DATE:	July 1, 2025
MAI NO.:	24001
DSA APPL. NO.:	02-122658
DSA FILE NO.:	10-28
PTN:	62125-41

**NEW CLASSROOM WING AT
SUNSET ELEMENTARY SCHOOL
COALINGA-HURON UNIFIED SCHOOL DISTRICT
COALINGA, KINGS COUNTY, CALIFORNIA**

ADDENDUM NO. 3

6 PREV. ELEC. YARD

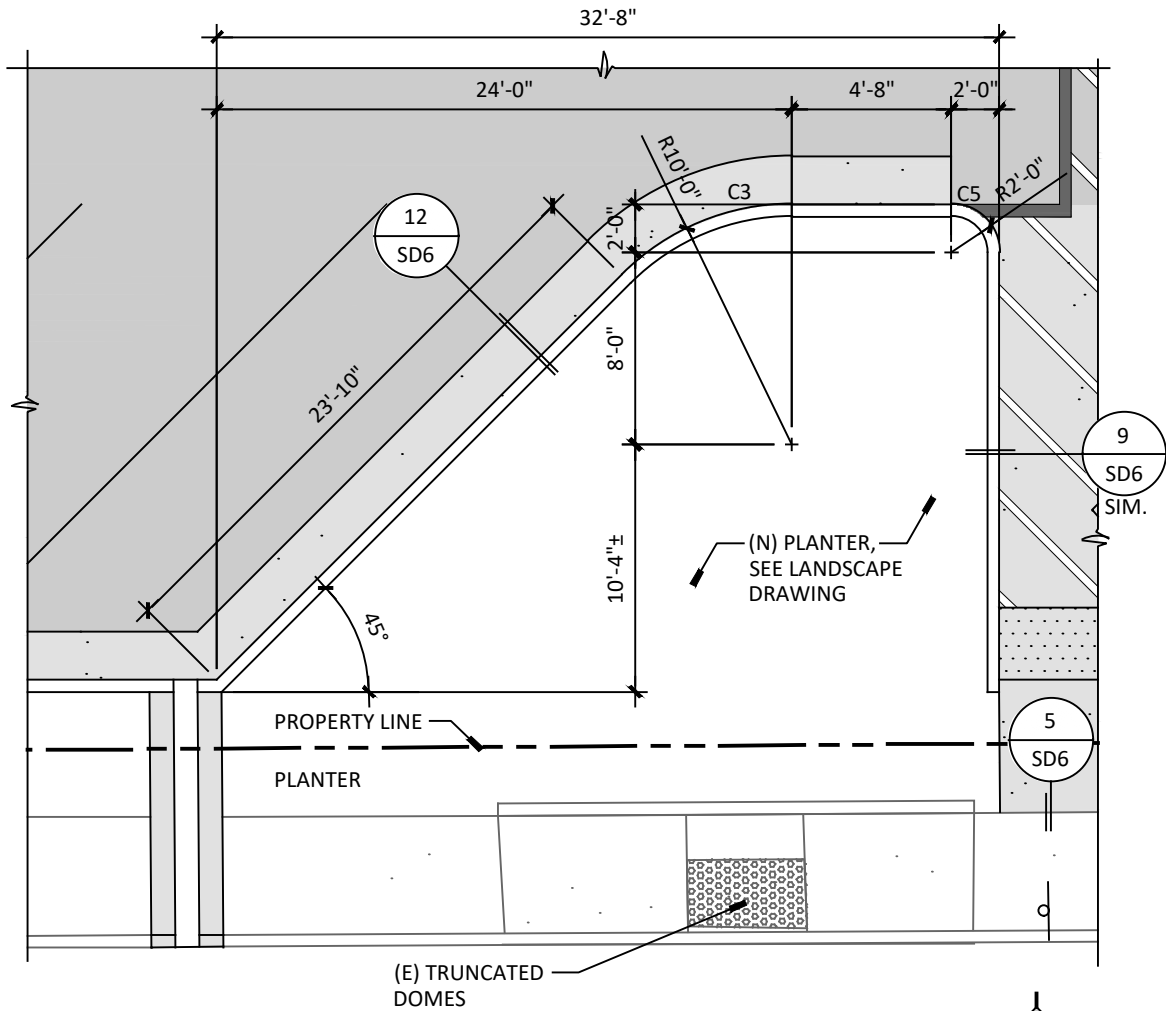
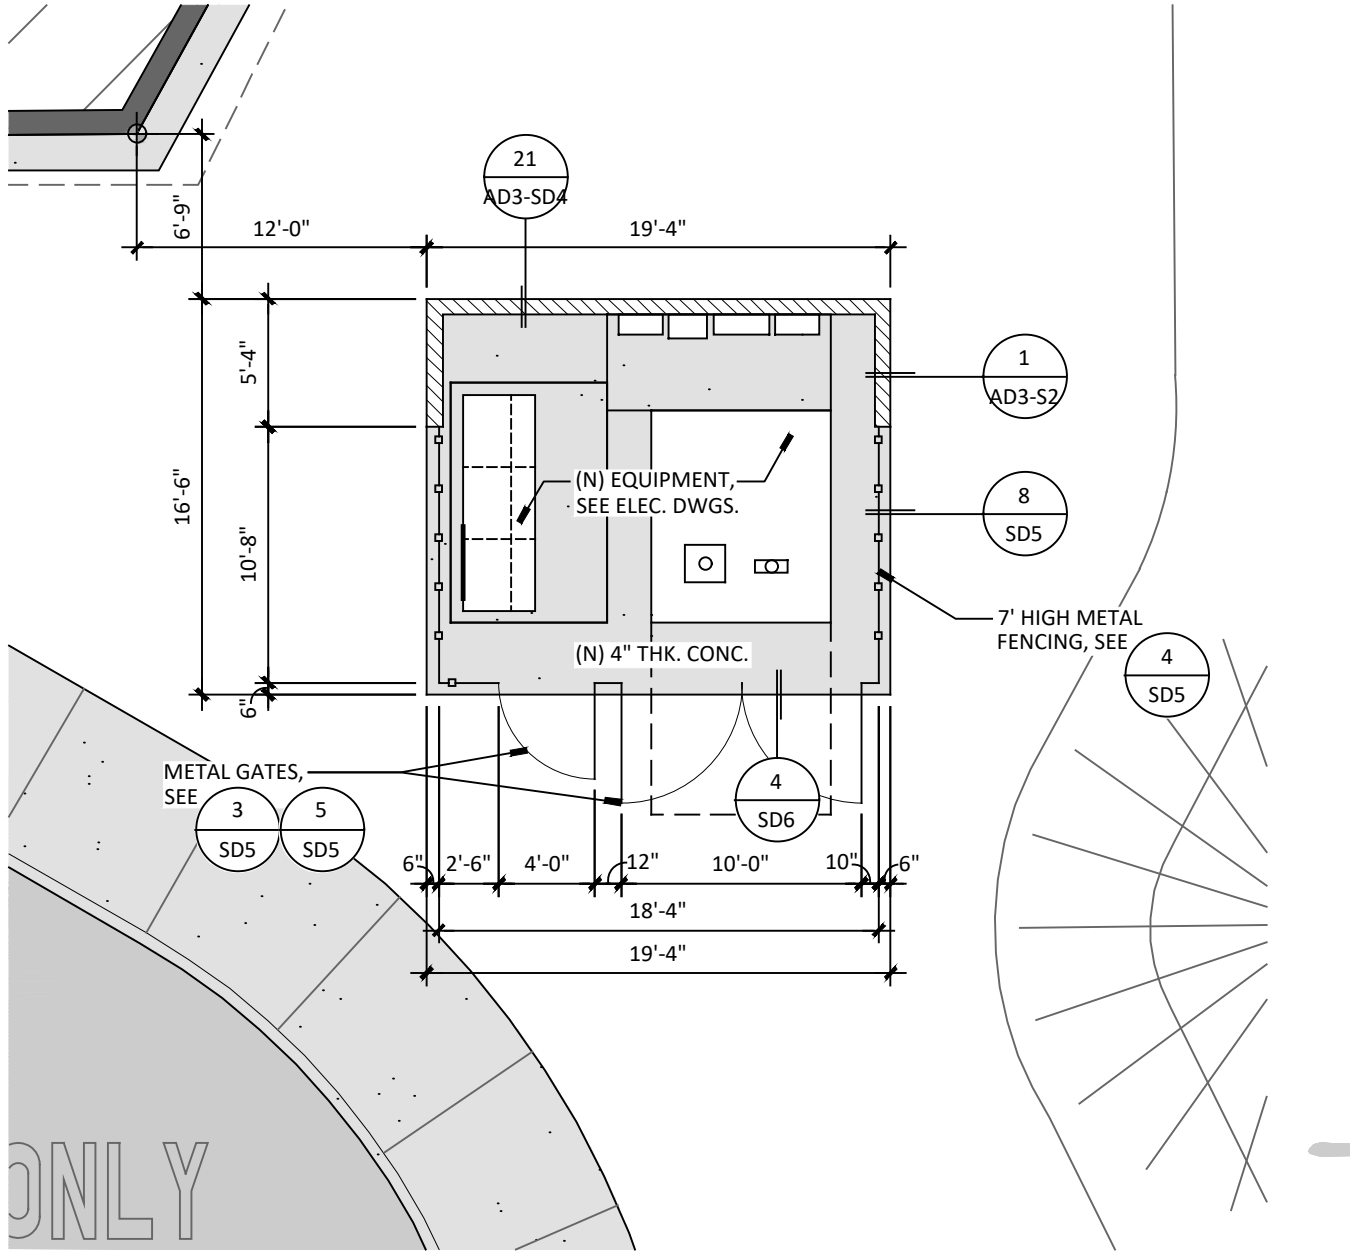
Revise detail 6 as shown on attached sheet AD3-SD4 Details 6 and 6A.

21

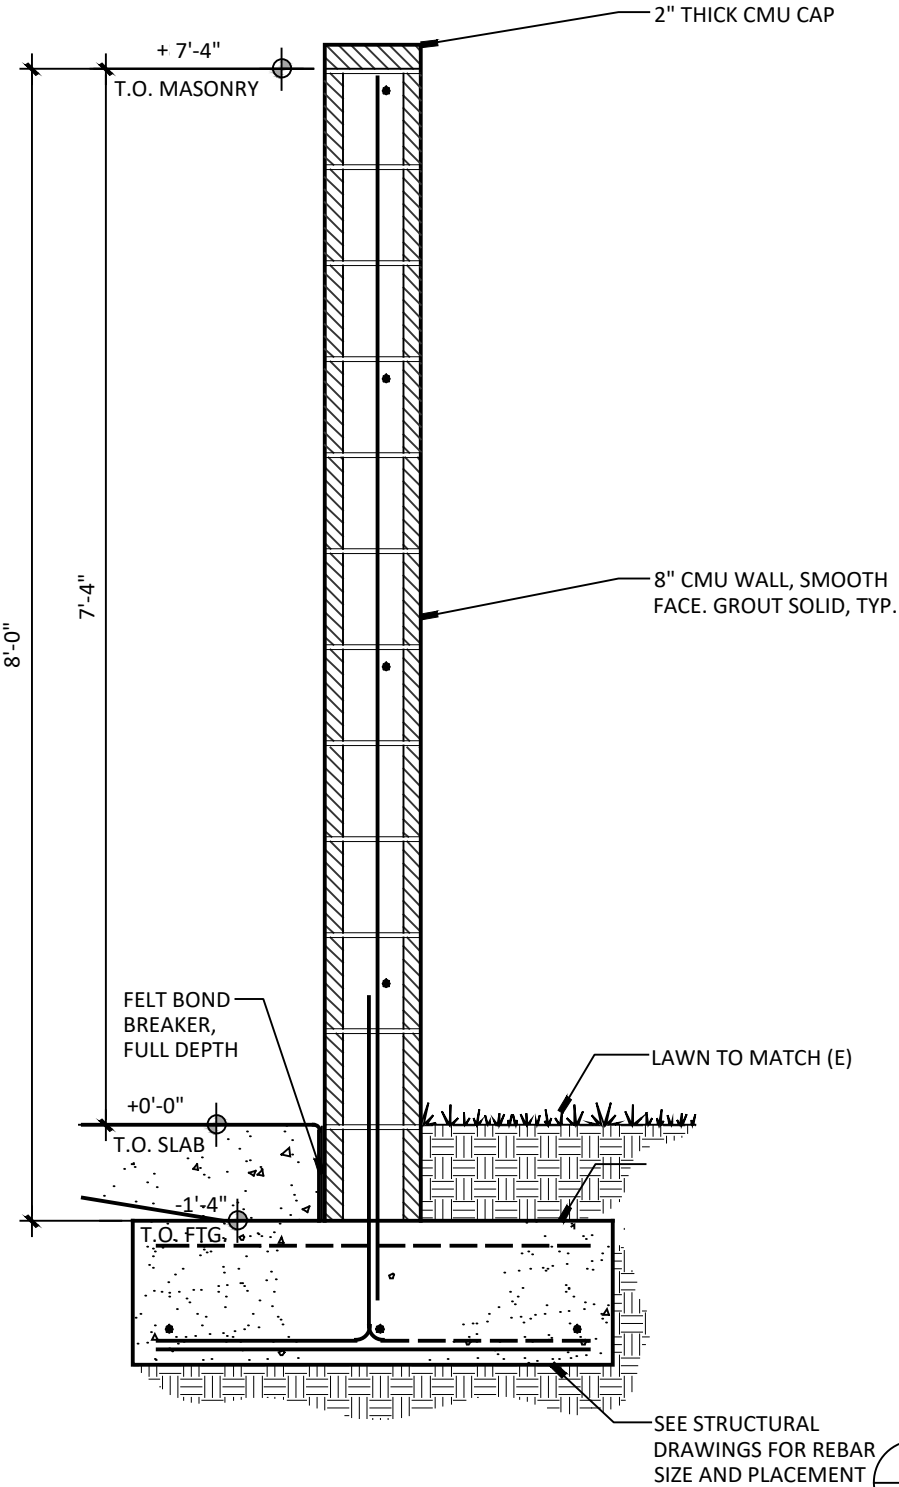
Revise detail 21 as shown on attached sheet AD3-SD4 Detail 21.

REVISED FIRE PROTECTION SITE PLAN

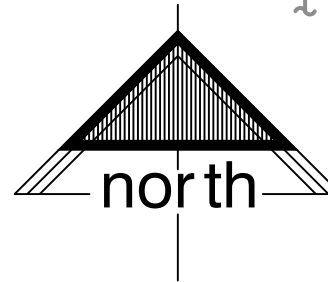
The 6" underground fire service piping has been revised due to a conflict with the electrical enclosure. The piping has been rerouted to avoid the enclosure. Refer to the clouded area on the attached sheet FS.1_ADD3.

ES1.1R

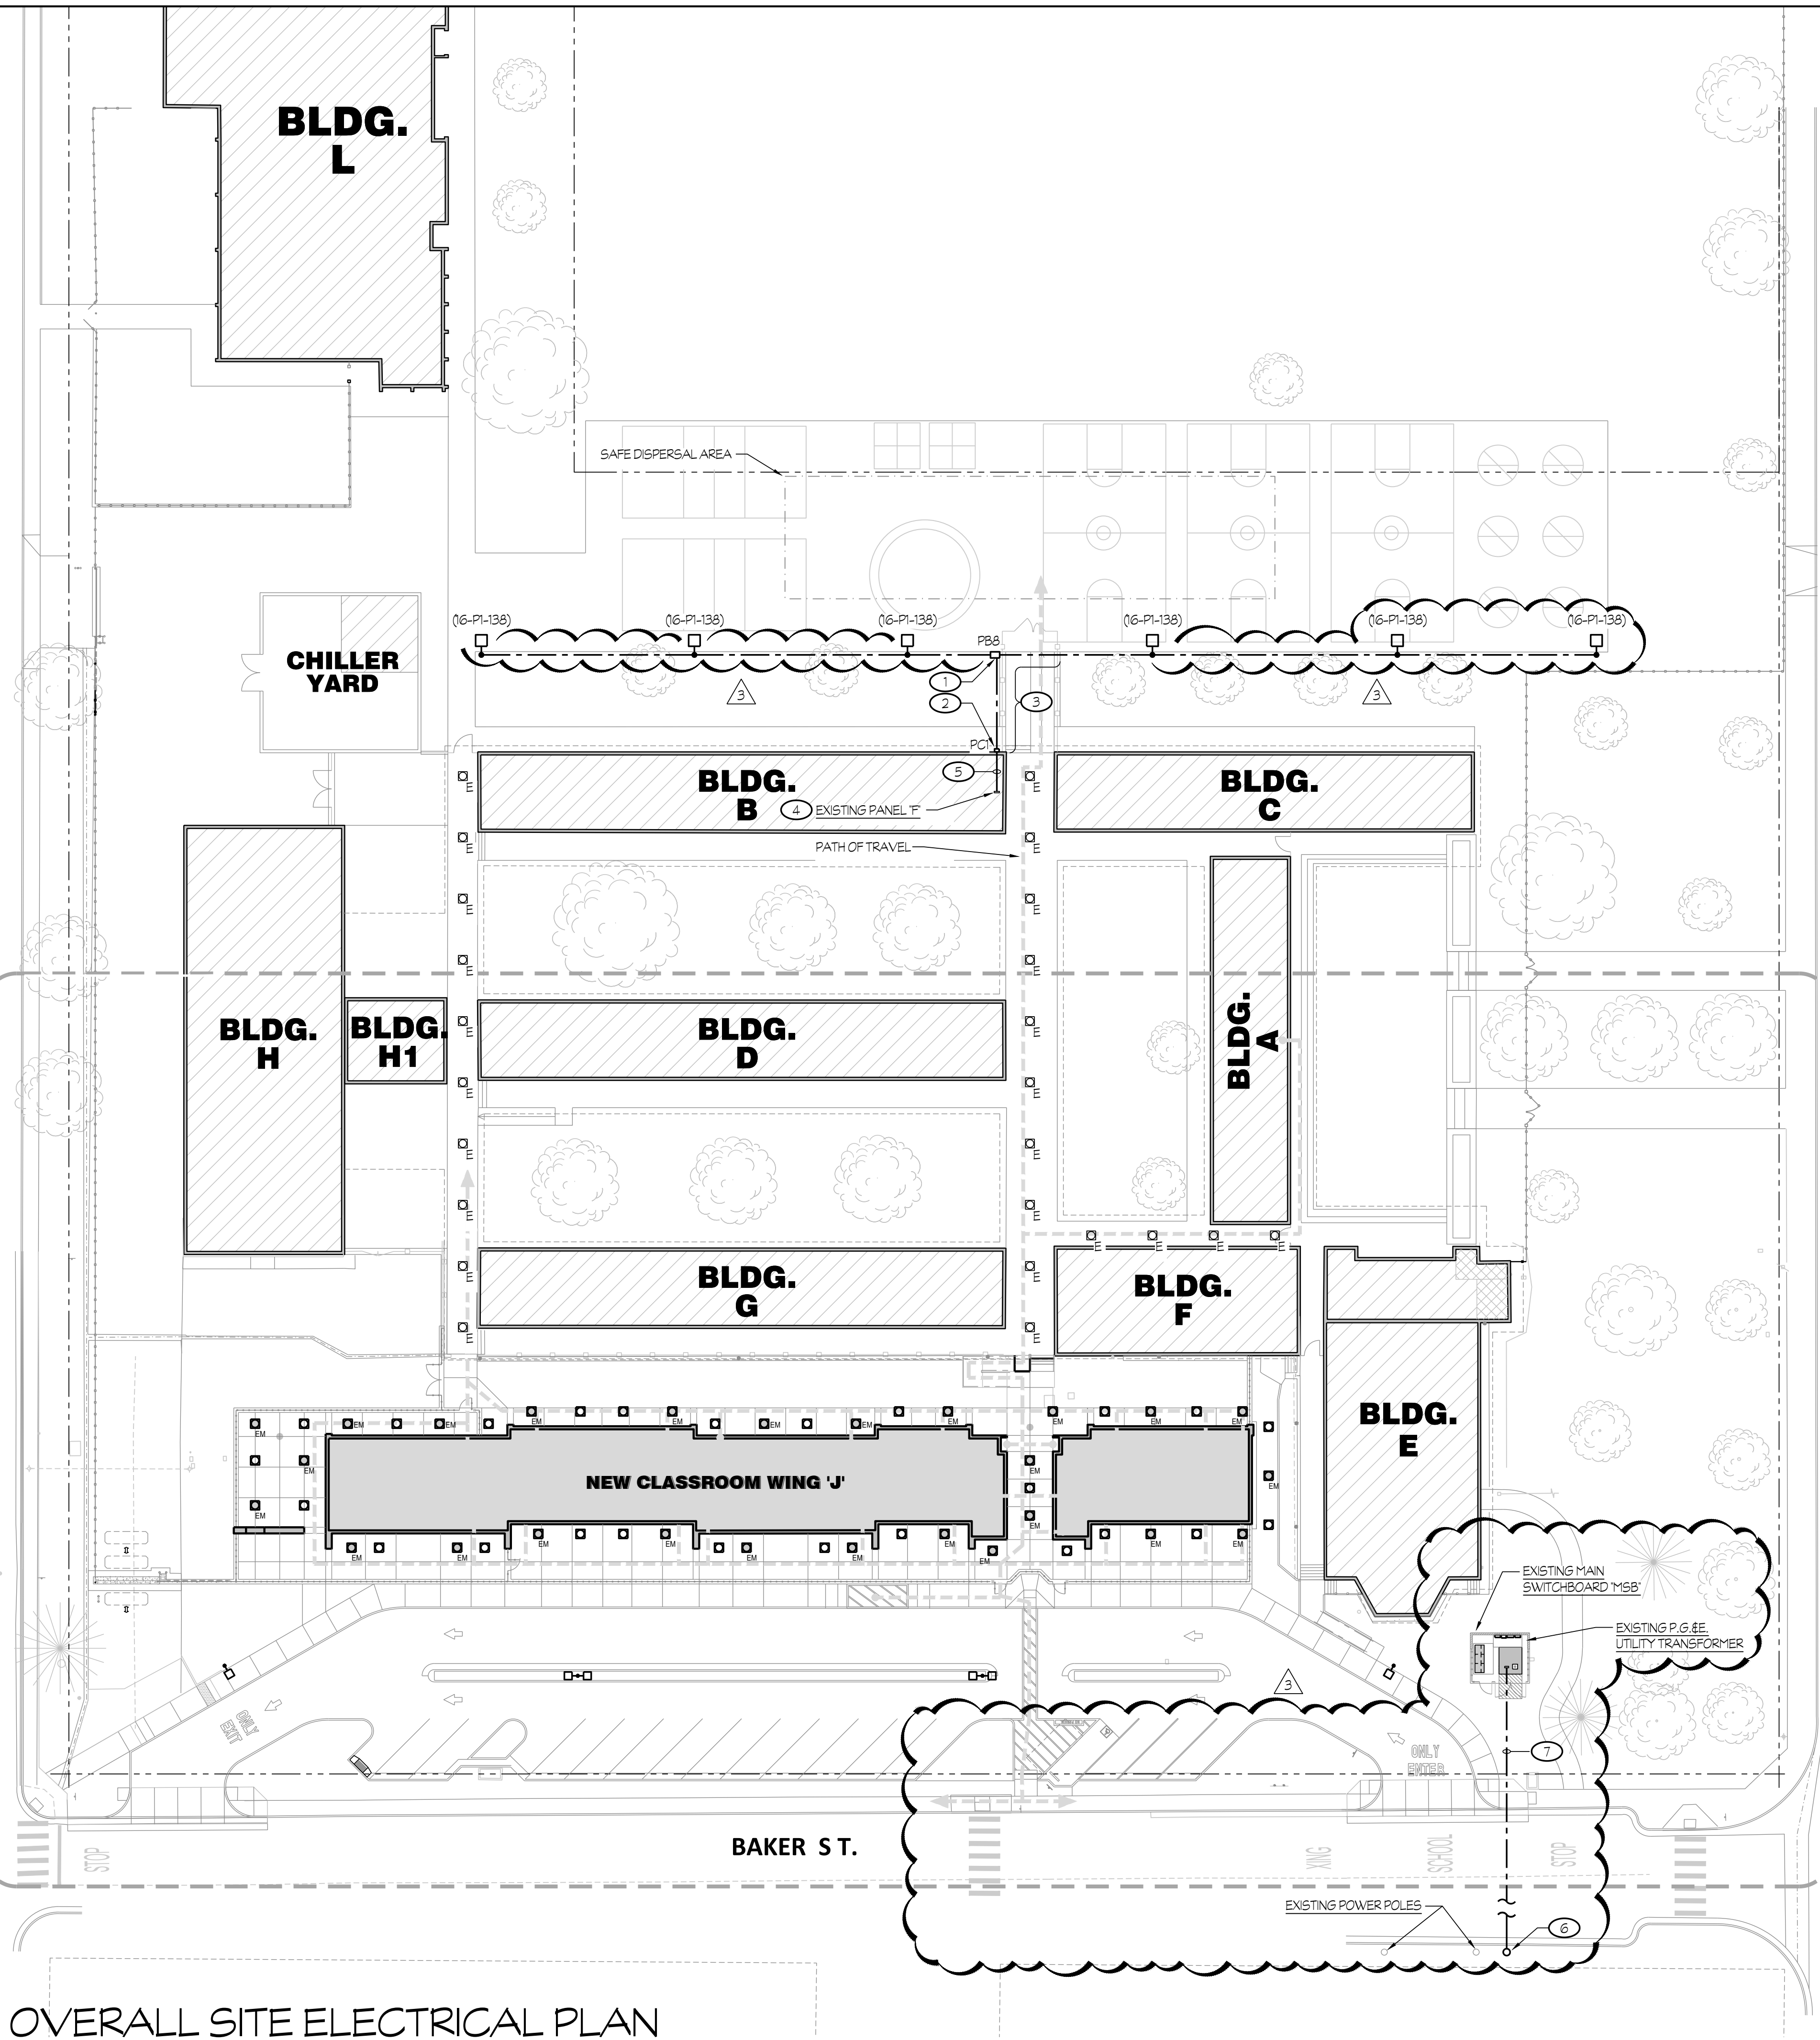
Replace with attached Sheet ES1.1R with clouded changes.
